Re: SCBP Buildings 1 & 2 Project

Subject: Notice of Availability of a Draft Environmental Impact Report
Sycamore Canyon Business Park Buildings 1 and 2 State Clearinghouse No.
2015081042

Figure 1: View of a warehouse of comparable height (CT reality, project adjacent to proposed project) taken at exactly 100 ft distance, which is the distance of proposed projects wall from residence property lines. Note extreme impact on home's view.

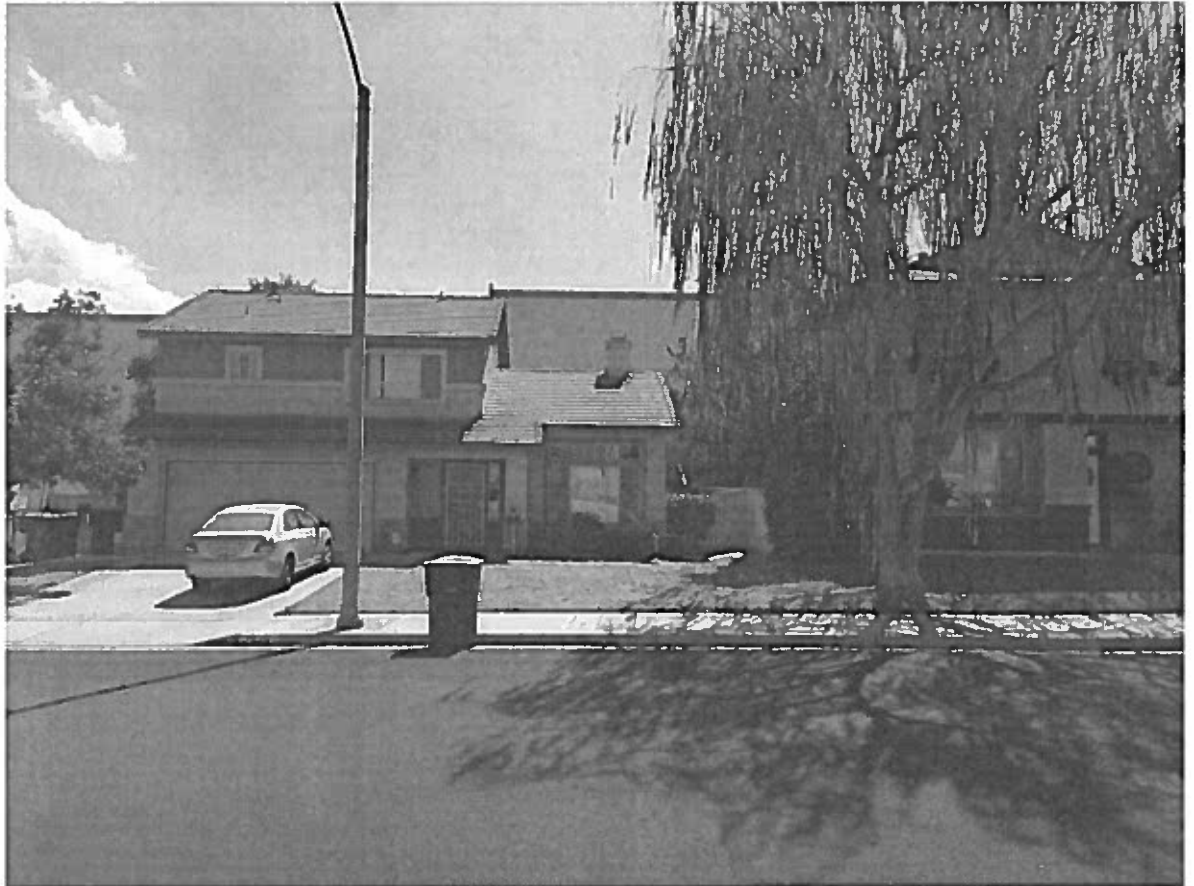
2. The presence of a 37 foot high wall located 100 ft from property boundaries along Northern line of properties will have extreme effects on the aesthetics of the neighborhood. This is already abundantly obvious based on the “CT” warehouses (“10” in Figure 6-1) built along the same boundary to the east of the proposed project. A photo (Figure 1) taken from

comparable wall measured 100 feet away is shown here for the expected aesthetics impact on homes on the Northern boundary of the project, especially the Easternmost homes here homes appear to be below level of warehouse.

Figure 3: View from backyard of northern residential properties. The flag represents the height of the wall and corner of proposed building nearest the northern residences. Red line added for emphasis of TOP of wall. View below will be that of large concrete wall replacing view.

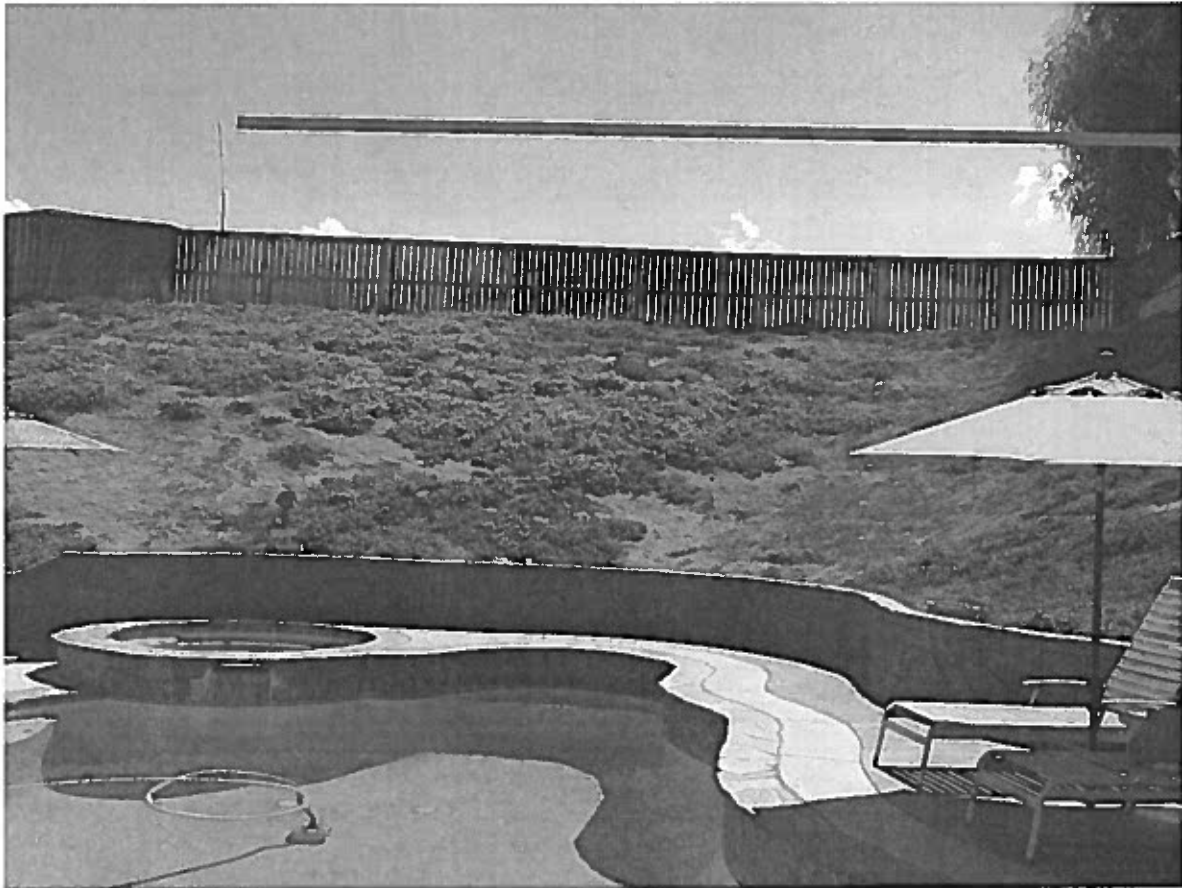
3. Further, the following sets of photographs are provided to show a more realistic impact of the proposed warehouse. The flag shown in the currently undeveloped areas are the height and location of the corner of the proposed project. While renderings in the draft EIR have attempted to make the impact appear small, one must wonder, which homes are actually shown? These photographs provided herein are actual pictures taken from homes in the neighborhood on the Northern boundary. It is imperative that for full disclosure of aesthetic impacts, homes along the entire Northern boundary, particularly to the East are considered. Given the steep slope that the current Northern boundary residents reside, the relative elevation of the distribution center to the homes varies significantly. This variation appears to be ignored in the current draft EIR. Renderings of view impacts on MOST impacted homes should be shown, not those properties with less significant impacts!. Figures 3 through 7 attempt to put a more realistic impact of the proposed project on aesthetics for residences on Northern project boundary.
